**COMMISSION OF ARCHITECTURAL REVIEW  
STAFF REPORT  
October 25, 2016 Meeting**

12. **CAR No. 16-154** (M. Jarreau)

**3005-3007 East Franklin Street  
St. John's Church Old and Historic District**

**Rehabilitate a multifamily building  
and construct new multifamily buildings.**

Richmond 1924-1925 vol. 2, 1925 Sanborn Map

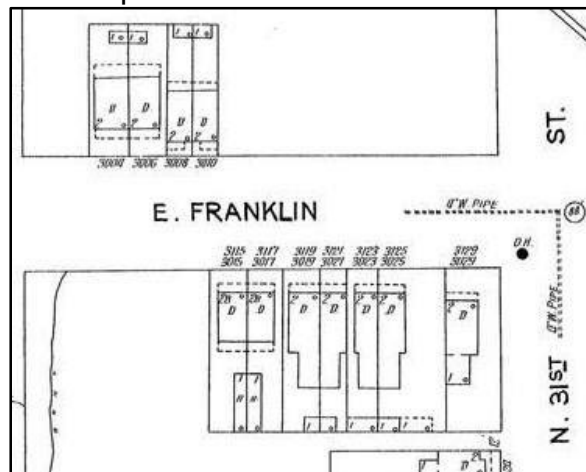
The subject block has been altered through the years, as seen in the Sanborn Map below. The proposed new construction restores a building presence closer to the sidewalk as was the historical pattern for the block.
